Real Public Safety Risks of Bentree RV Park

PRESENTED BY STAGECOACH RANCH RESIDENTS
TO LAKE TRAVIS ESD 6 BOARD OF DIRECTORS
JULY 30, 2019

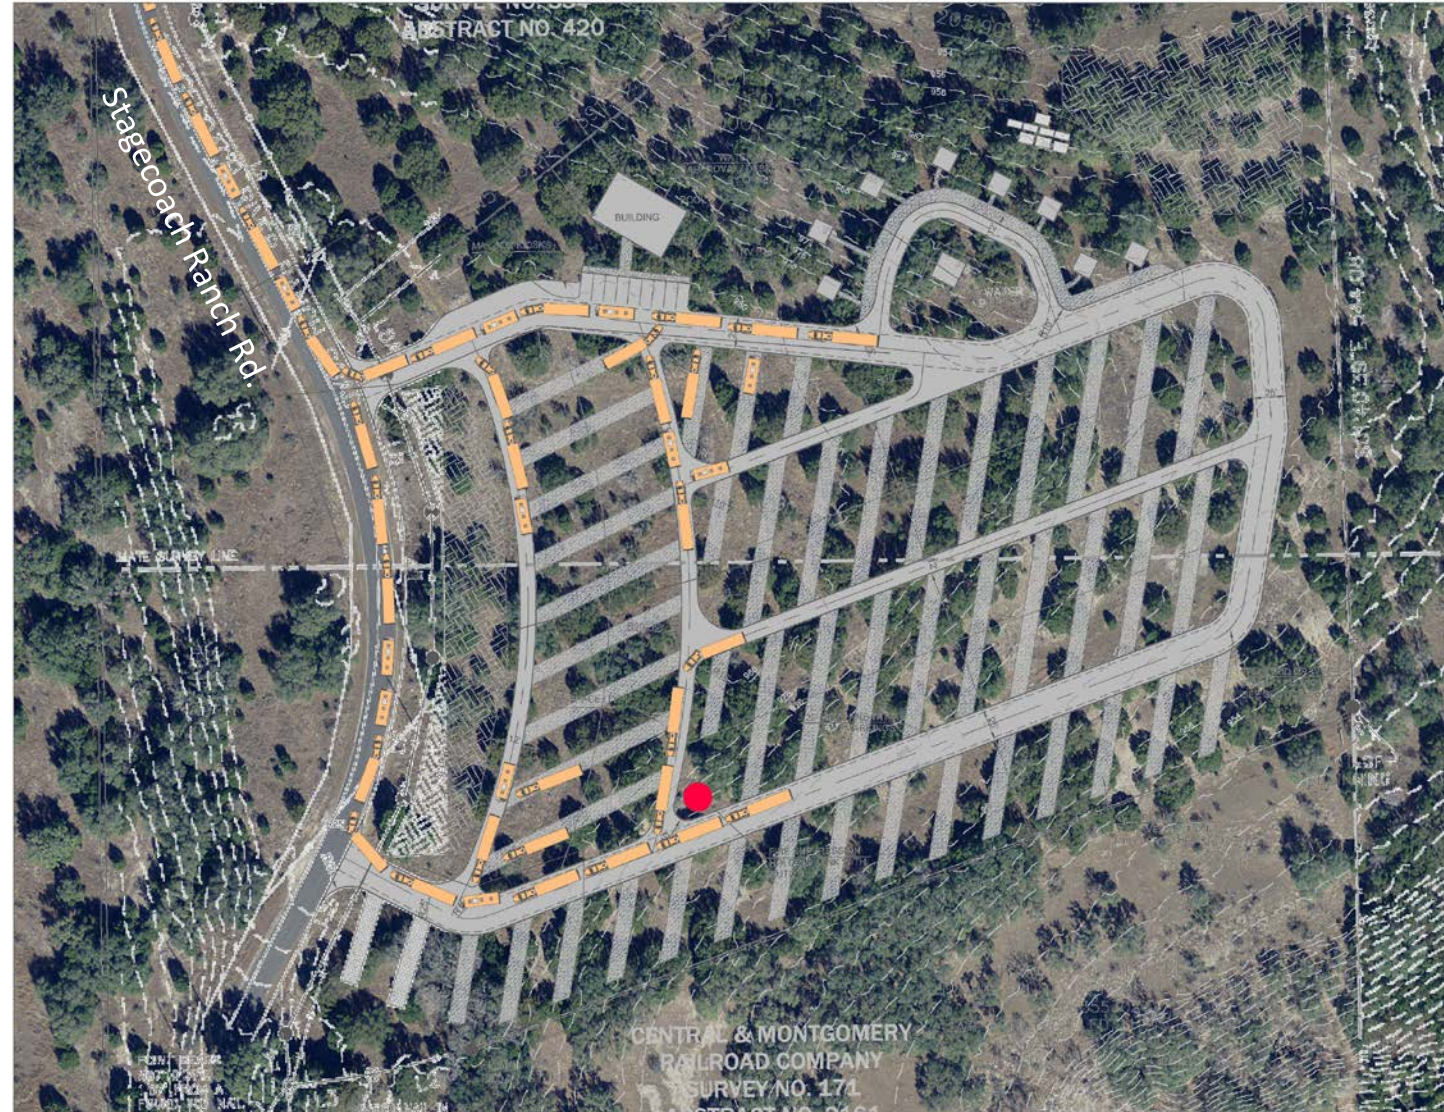
- ❖ Reliant upon Stagecoach Ranch Rd for **2,167 lf** (0.41 mi)
- ❖ **Reliant upon a 19' – 22'** wide paved section for two-way traffic, at **12.5% grade**.
 - ❖ Typical **local** street (less than 1,000 ADT) minimum width = 31' back-to-back
 - ❖ Typical **collector** street **minimum** width = 36'-40'
- ❖ Claiming an exemption from providing any public improvements
 - ❖ 10 ac platting exception
 - ❖ No TIA provided
 - ❖ (Comparable ITE codes would yield 400 – 1,100 daily trips)*

+240 Existing Stagecoach Ranch Residents using same / only evacuation route

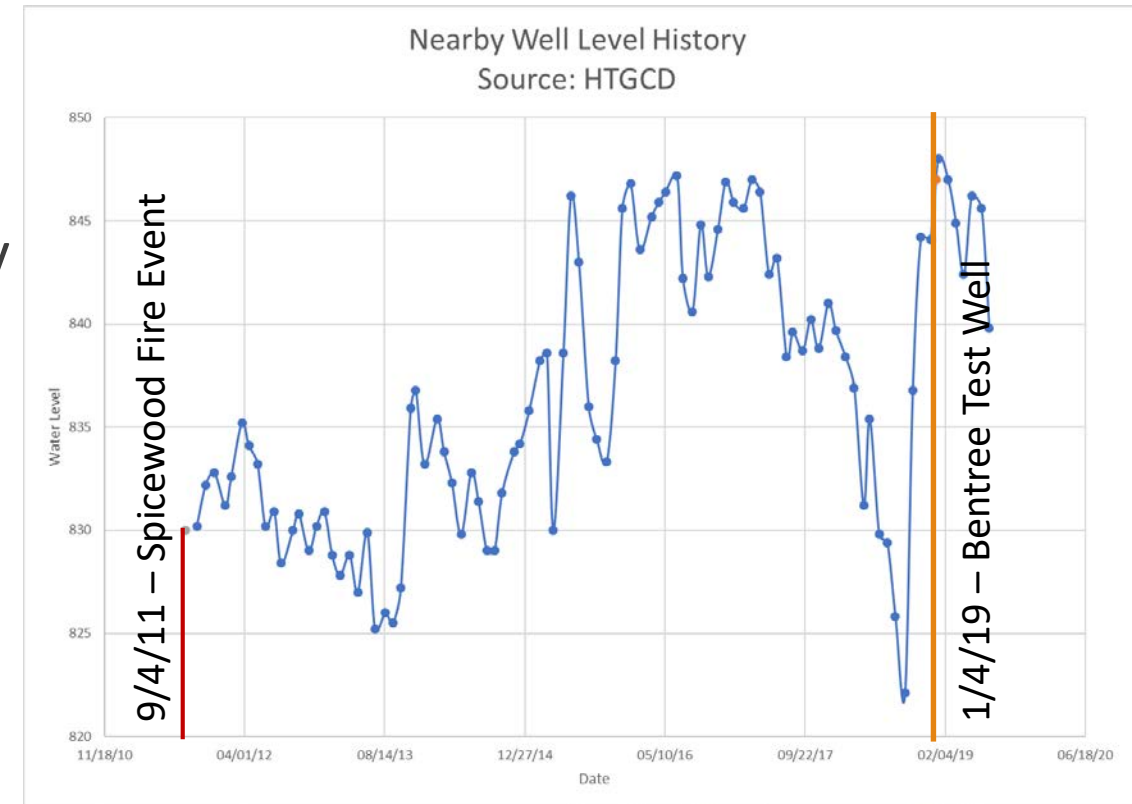
Proposed dry hydrant system is inadequate

- Hydrants must be located within 100' of all structures and pads
- **Each** dry hydrant must supply **1000 gpm** with max pressure loss of 8.7 psi
- Is 1000 gpm sufficient? Assuming 2 hour duration?
- NFPA 1194?
- NFPA 1142?
